ADDENDUM NO. 1 TO PROJECT NO. 44850

**PLUMBING WORK
PROVIDE ALARM & PUMP CUT OFF TO SUMP PITS B1-8, 10-12, 14-17
HUTCHINGS PSYCHIATRIC CENTER
620 MADISON STREET
SYRACUSE, NY 13210-2319**

December 29, 2014

DRAWING NUMBER:
E-107

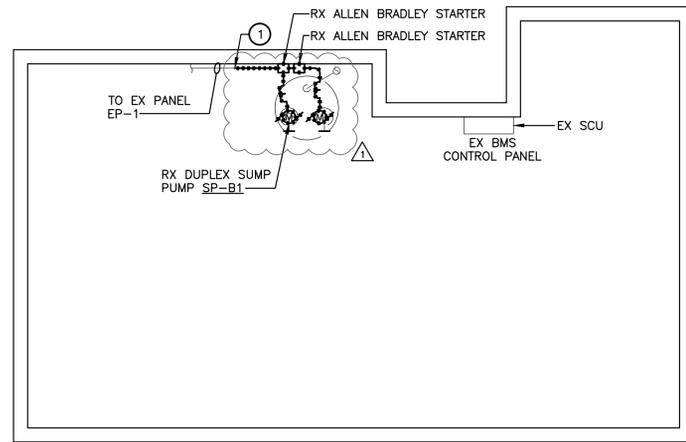
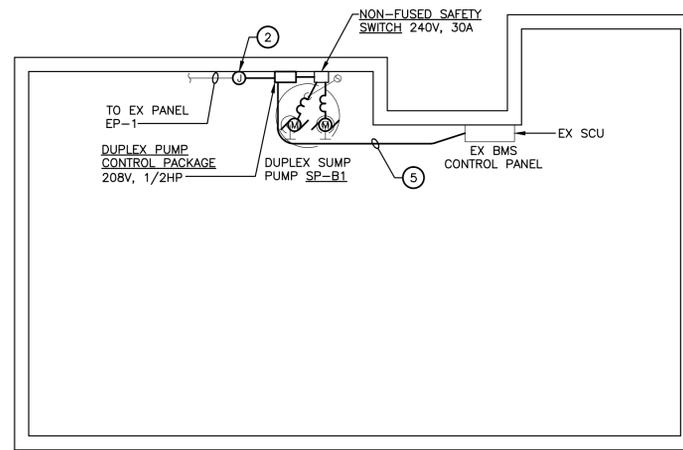
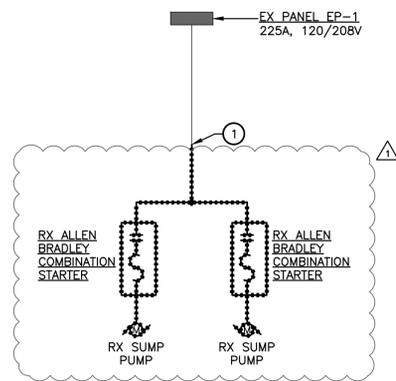
9. Drawing E-107: Refer to attached drawing E-107 for drawing revisions.

1. NON-FUSED SAFETY SWITCH TO BE PROVIDED AS PART OF DUPLEX PUMP CONTROL PACKAGE. THE DISCONNECTS SHALL BE CONTAINED IN A SINGLE NEMA 4X BOX AND SHALL BE LOCKABLE.
2. EXISTING PUMP CONTROL UNITS SHALL BE TURNED OVER TO THE FACILITY UPON REMOVAL.

- 1 REMOVE EXISTING SAFETY SWITCH AND ALL ASSOCIATED LOAD SIDE WIRING AND CONDUIT. MAINTAIN EXISTING LINE SIDE FEEDER CIRCUIT FOR RE-USE.
- 2 INSTALL 4"x4" GALVANIZED STEEL JUNCTION BOX AND SPLICE TO EXISTING BRANCH CIRCUIT FEEDING THE EXISTING SAFETY SWITCH TO BE REMOVED.
- 3 1 SET OF 3-#12 AWG + 1-#12 AWG GROUND IN 3/4" RGS CONDUIT.
- 4 1 SET OF 3-#12 AWG + 1-#12 AWG GROUND IN 3/4" LIQUID TIGHT FLEXIBLE METAL CONDUIT.
- 5 PROVIDE 4-#18 AWG CONTROL WIRES IN 3/4" RGS CONDUIT FROM DUPLEX SUMP PUMP CONTROL PACKAGE TO EXISTING SCU PANEL TO INDICATE "HIGH" AND "OIL" ALARMS.

MARK	DATE	DESCRIPTION
⚠	12-23-2014	ADDENDUM NO. 1
	11-21-2014	BID DOCUMENTS
PROJECT NUMBER:	44850	
DESIGNED BY:	JTM	
DRAWN BY:	TNC	
FIELD CHECK:		
APPROVED:	WAE	
SHEET TITLE:	BUILDING 10 - BASEMENT	
DRAWING NUMBER:	E-108	
SHEET 30	OF 37

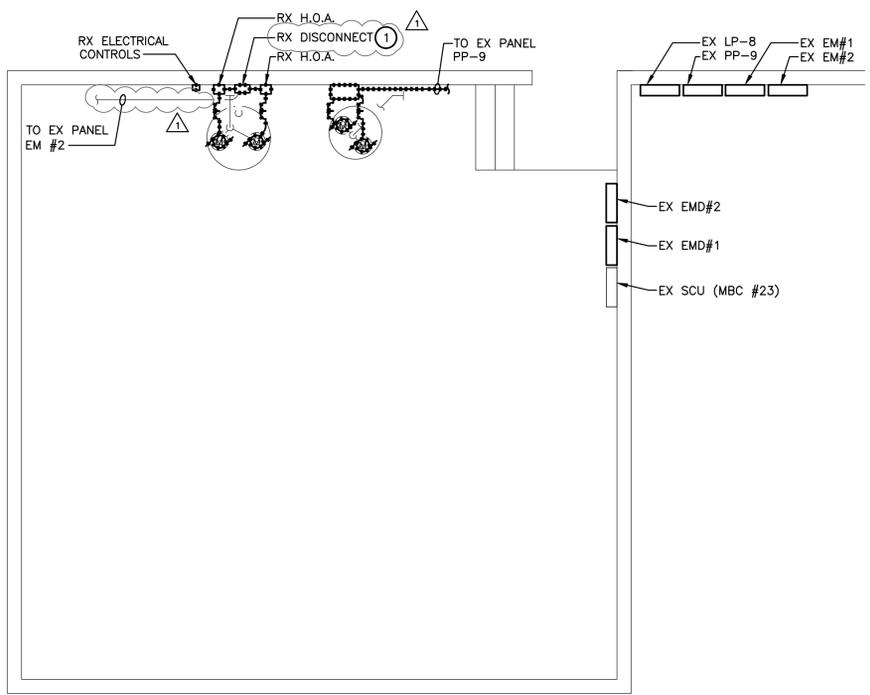
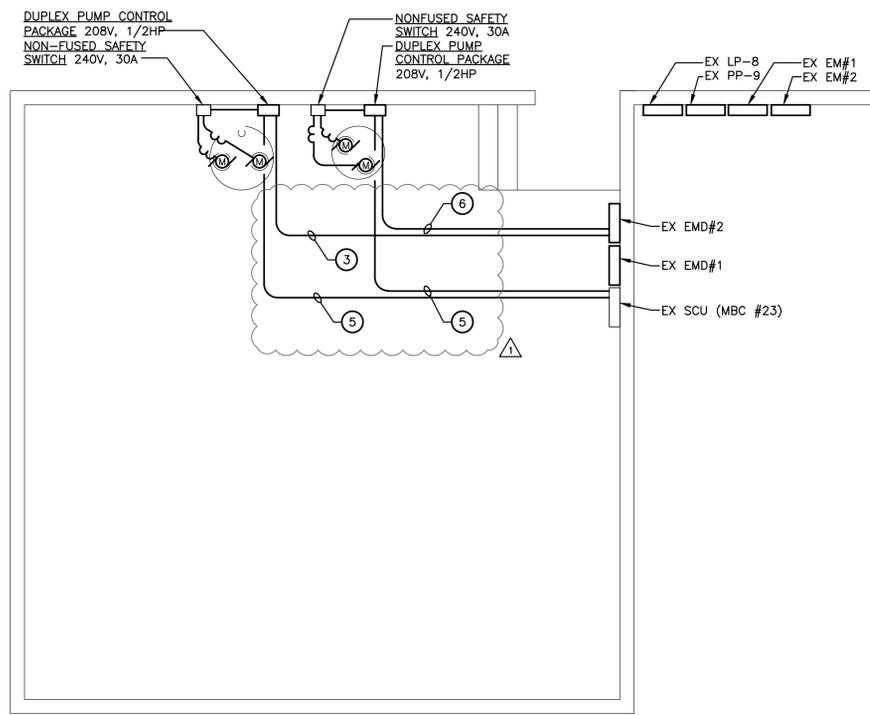
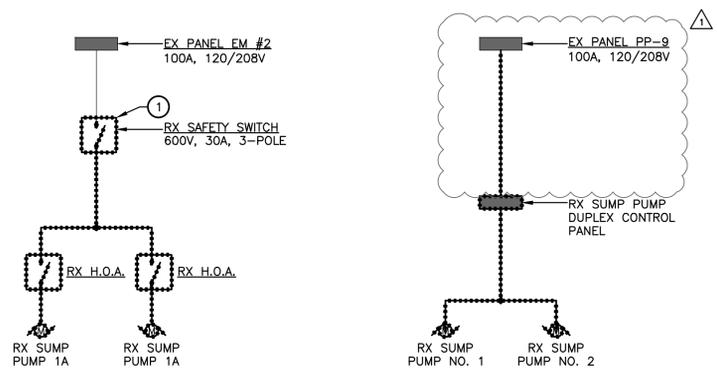
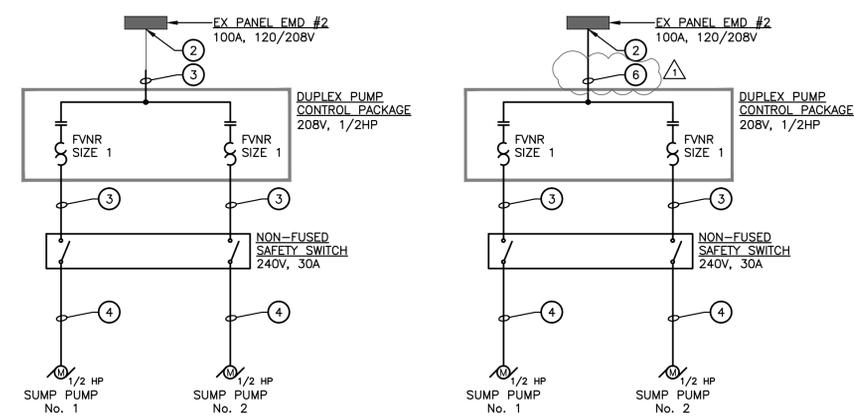
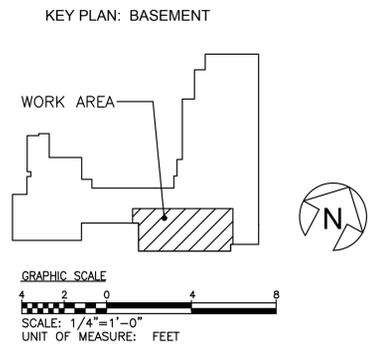
10. Drawing E-108: Refer to attached drawing E-108 for drawing revisions.

- NON-FUSED SAFETY SWITCH TO BE PROVIDED AS PART OF DUPLEX PUMP CONTROL PACKAGE. THE DISCONNECTS SHALL BE CONTAINED IN A SINGLE NEMA 4X BOX AND SHALL BE LOCKABLE.
- THE CONTRACTOR MAY REUSE EXISTING CONDUIT FROM THE JUNCTION BOX LOCATED ADJACENT TO THE EXISTING SUMP PUMP CONTROL ASSEMBLIES BACK TO THE EXISTING SCU PANEL FOR NEW WORK

- REMOVE EXISTING SAFETY SWITCH AND ALL ASSOCIATED WIRING AND LOAD SIDE CONDUIT. MAINTAIN EXISTING LINE SIDE CONDUIT FOR RE-USE.
- PROVIDE NEW 3P-20A CIRCUIT BREAKER IN EXISTING PANELBOARD EMD#2. LABEL "DUPLEX SUMP PUMP" ON PANEL SCHEDULE.
- 1 SET OF 3-#12 AWG + 1-#12 AWG GROUND IN EXISTING 3/4" RGS CONDUIT.
- 1 SET OF 3-#12 AWG + 1-#12 AWG GROUND IN 3/4" LIQUID TIGHT FLEXIBLE METAL CONDUIT.
- PROVIDE 4-#18 AWG CONTROL WIRES IN 3/4" RGS CONDUIT FROM DUPLEX SUMP PUMP CONTROL PACKAGE TO EXISTING SCU PANEL TO INDICATE "HIGH" AND "OIL" ALARMS.
- 1 SET OF 3-#12 AWG + 1-#12 AWG GROUND IN 3/4" RGS CONDUIT.

PROJECT NO:	44850	SCALE:	AS SHOWN
DATE:	12/23/14	DWG NO:	SK-P108

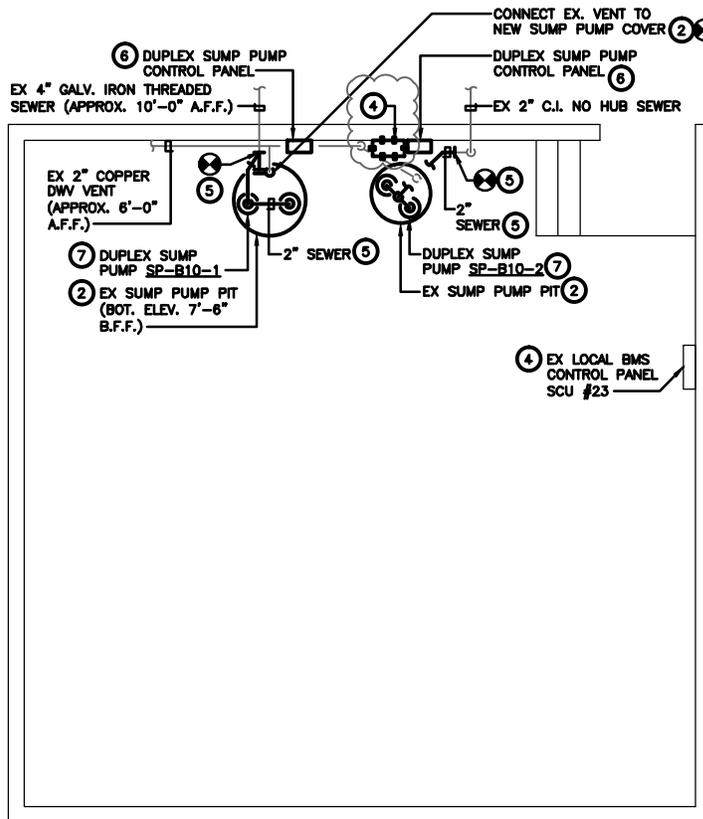
2. Drawing P-108: Refer to the attached sketch SK-P108 for drawing revisions.
3. Drawing P-111: Refer to the attached sketch SK-P111 for drawing revisions.

- ① REMOVE EXISTING SUMP PUMPS & ASSOCIATED DEVICE INCLUDING:
 - DISCHARGE PIPING & FITTINGS
 - GATE VALVE
 - CHECK VALVE
 - UNION
 - PUMP FLOAT CONTROLS
 - LEVEL CONTROLS

- PUMP ALTERNATING SWITCH
- ② REMOVE EXISTING SUMP PUMP COVER. PROVIDE NEW 1/4" THICK DUPLEX STEEL SUMP COVER. RECONNECT EXISTING VENT PIPING. SEAL ALL UN-USED COVER OPENINGS.

- ③ EX LOCAL BMS CONTROL PANEL—DISCONNECT EXISTING SUMP PUMP HIGH WATER ALARM.
- ④ RX LOCAL BMS CONTROL PANEL.
- ⑤ PROVIDE 2-INCH SUMP PUMP DISCHARGE PIPING, UNION, CHECK VALVE, AND GATE VALVE. CONNECT TO EXISTING 4-INCH SEWER PIPING (TYP. OF 2).

- ⑥ PROVIDE NEW DUPLEX SUMP PUMP CONTROL PANEL W/FLOAT CONTROLS AND OIL DETECTION SYSTEM.
- ⑦ INSTALL NEW DUPLEX SUMP PUMP WITH 2" DISCHARGE PIPING AND CONNECT TO EXISTING 4" SEWER PIPE. PROVIDE UNION, CHECK VALVE AND GATE VALVE FOR EACH PUMP. PROVIDE DUPLEX PUMP FLOAT & ALTERNATING CONTROLS WITH OIL DETECTION SYSTEM.

<p>SHEET TITLE: BUILDING 1 – BASEMENT</p>			
<p>PROJECT: ADDENDUM NO. 1 TO PROJECT NO. 44850 HUTCHINGS PSYCHIATRIC CENTER SYRACUSE, NY</p>		<p>PROJECT NO: 44850</p>	<p>SCALE: AS SHOWN</p>
		<p>DATE: 12/23/14</p>	<p>DWG NO: SK-E101</p>

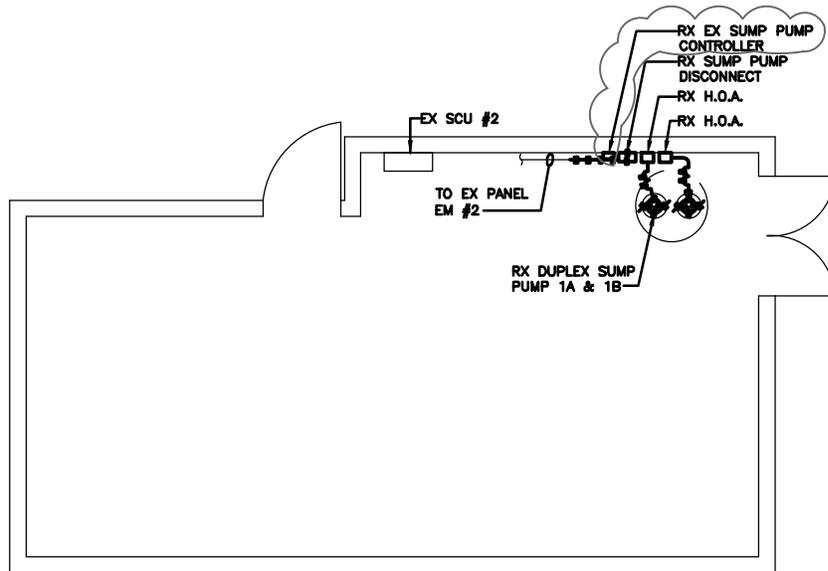
4. Drawing E-101: Refer to the attached sketch E-101 for drawing revisions.
5. Drawing E-103: Add General Note No. 2: “EXISTING PUMP CONTROL UNITS SHALL BE TURNED OVER TO THE FACILITY UPON REMOVAL.”

1. NON-FUSED SAFETY SWITCH TO BE PROVIDED AS PART OF DUPLEX PUMP CONTROL PACKAGE. THE DISCONNECTS SHALL BE CONTAINED IN A SINGLE NEMA 4X BOX AND SHALL BE LOCKABLE.
2. EXISTING PUMP CONTROL UNIT SHALL BE TURNED OVER TO THE FACILITY UPON REMOVAL.

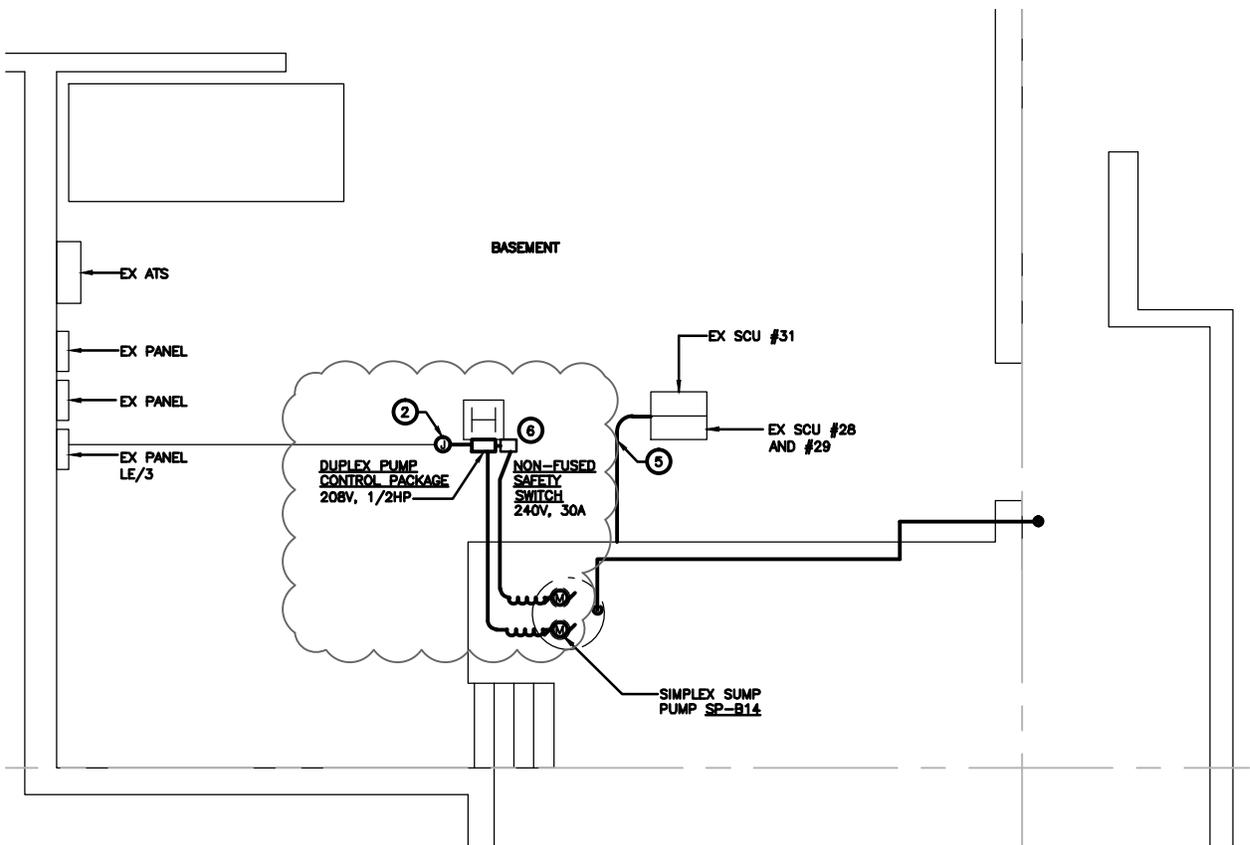
12. Drawing E-111: Refer to attached sketch SK-E111 for drawing revisions.

⑥ NON-FUSED SAFETY SWITCH AND DUPLEX PUMP CONTROL PANEL SHALL BE CHANNEL MOUNTED ON THE COLUMN SHOWN AND FASTENED SECURELY TO THE FLOOR. MOUNTING HEIGHT SHALL BE 60" AFF TO THE TOP OF THE CONTROL PANEL.
